Monitoring Report MY05

**Sandy Bridge Restoration Site
DMS Contract 6400
DMS Project Number 96920**

Re: Response to Sandy Bridge Farm MY05 Report Comments

DATE: NOV 2021
 SCALE: GRAPHIC
 CURRENT CONDITION PLAN VIEW

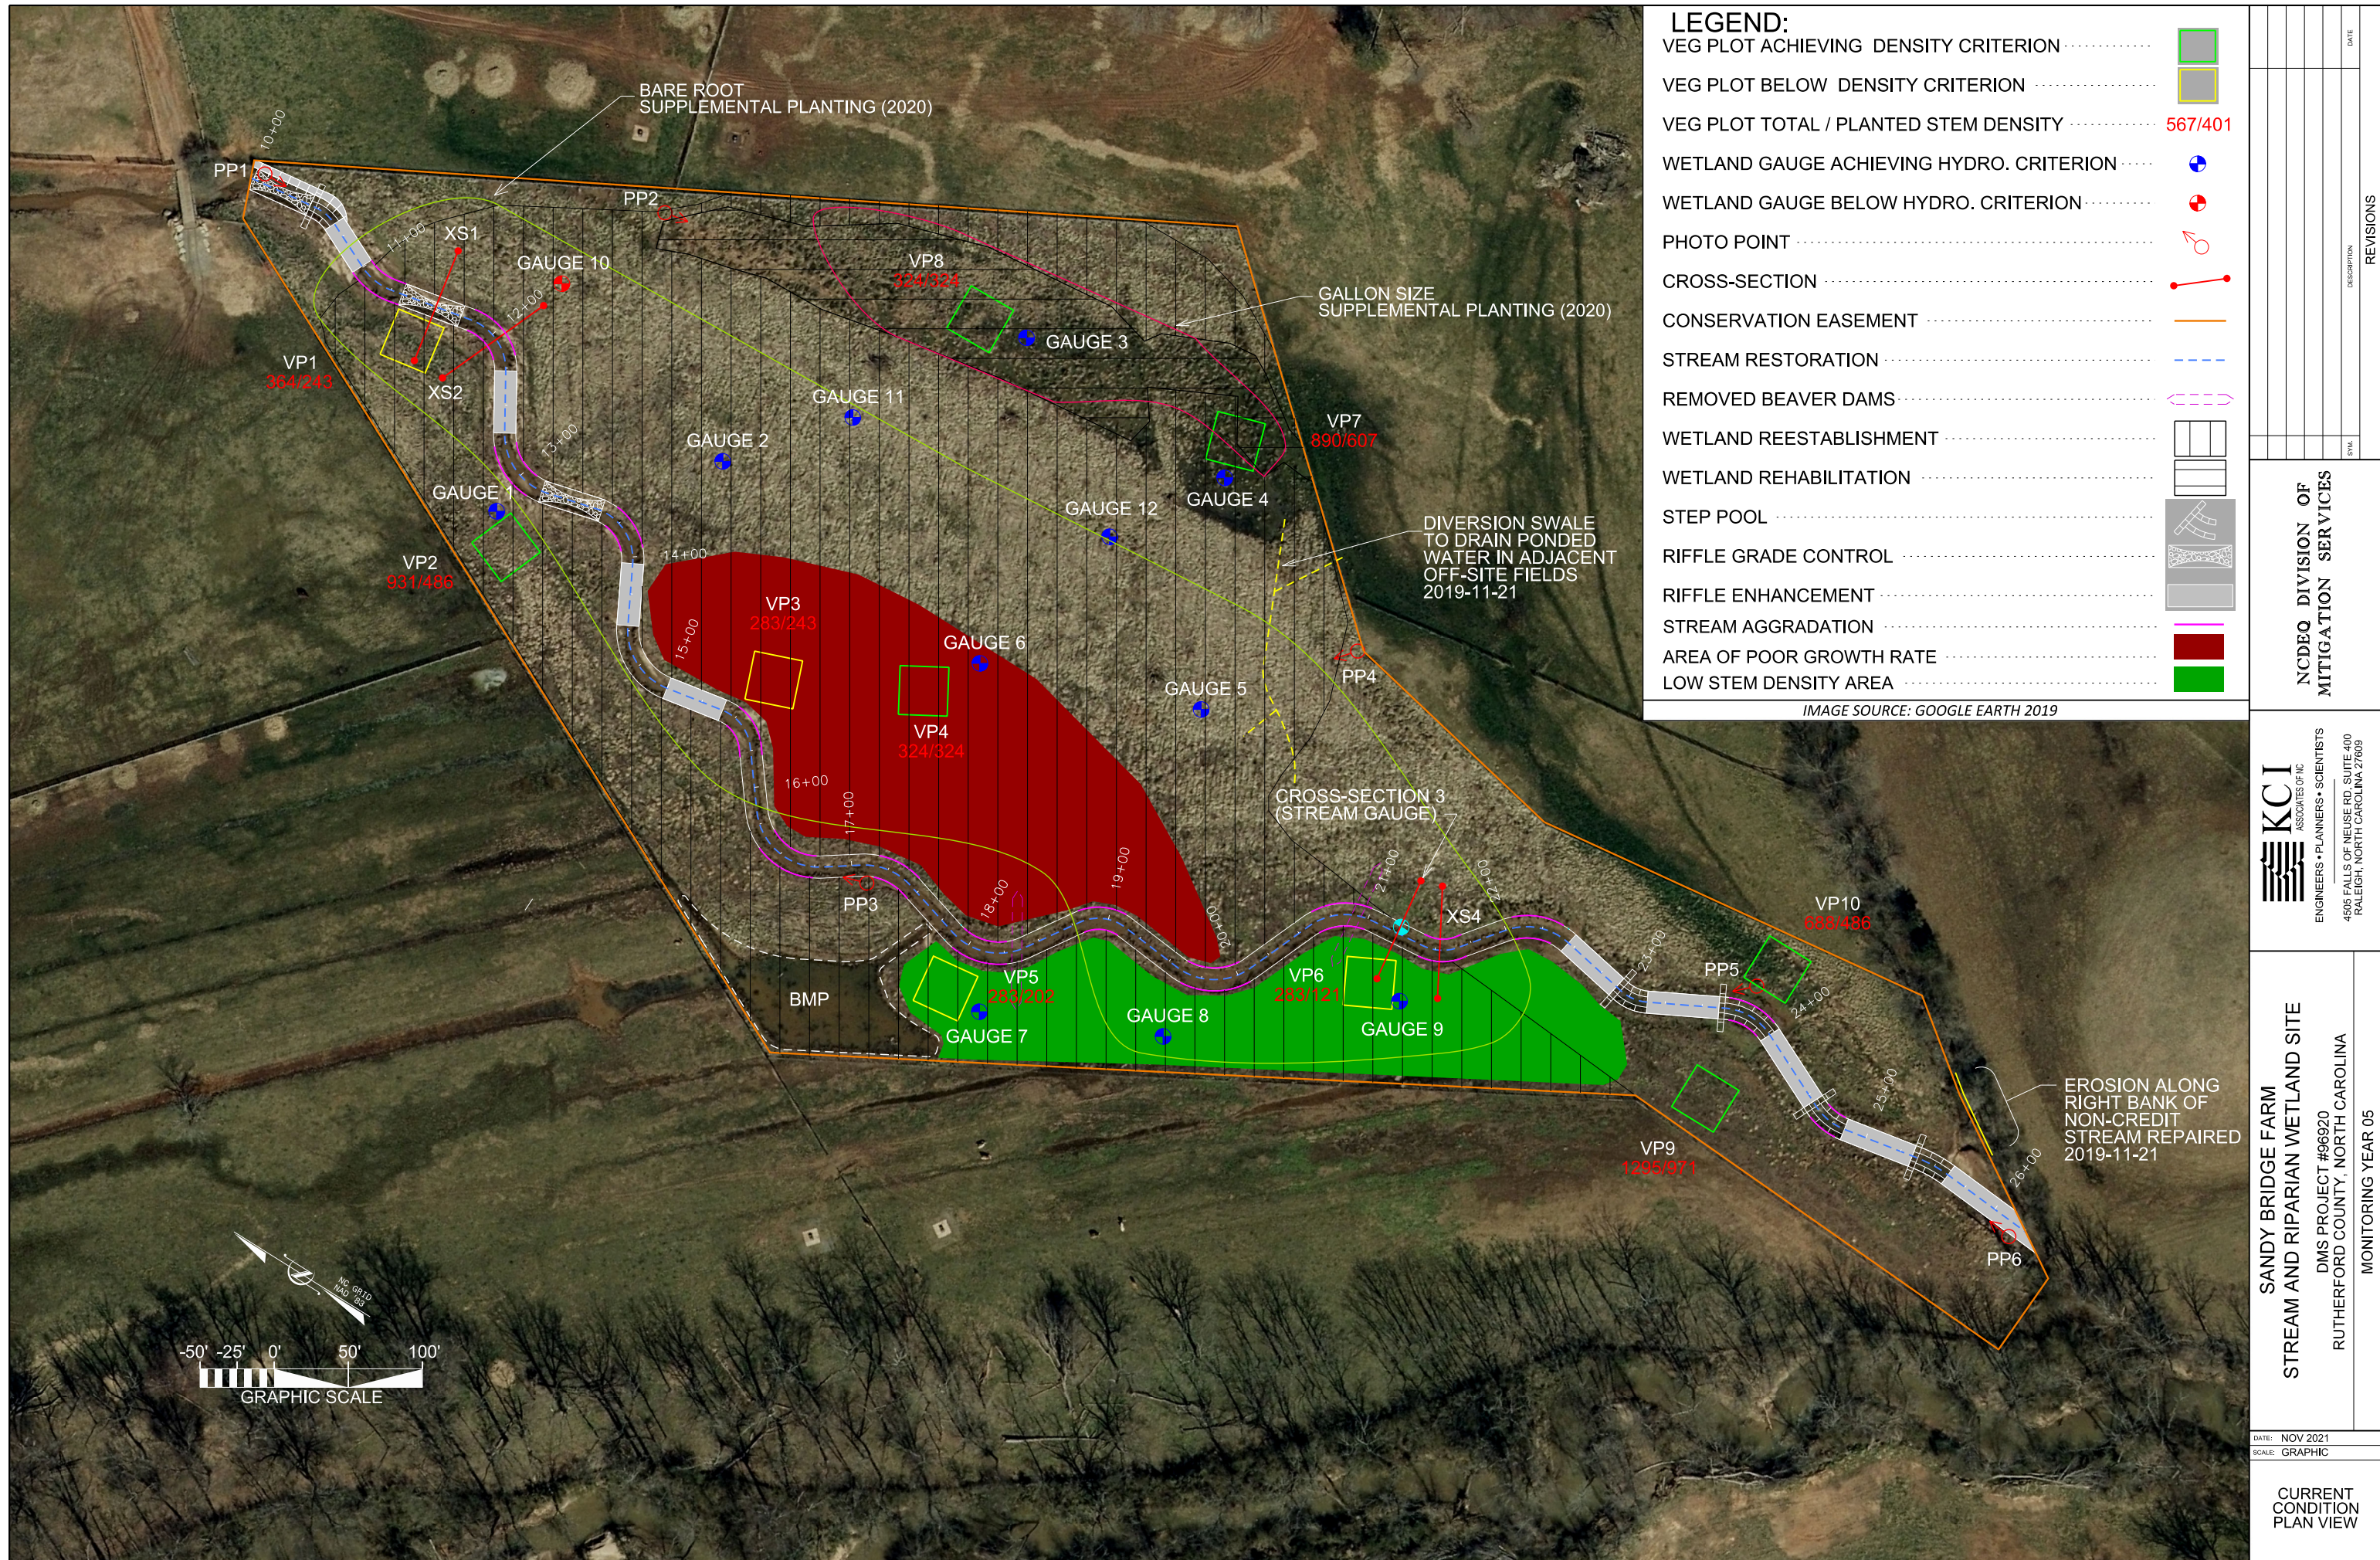
- Please add a call out for the ponded BMP area on the CCPV, see Kim’s 6/30/2021 email.
KCI Response: This change has been made.
- Can the aerial photo in the Site Asset Map be updated? This 2015 photo shows the old channel alignment and pre-construction conditions.
KCI Response: The aerial photo in the Site Asset Map has been updated to 2019 imagery.
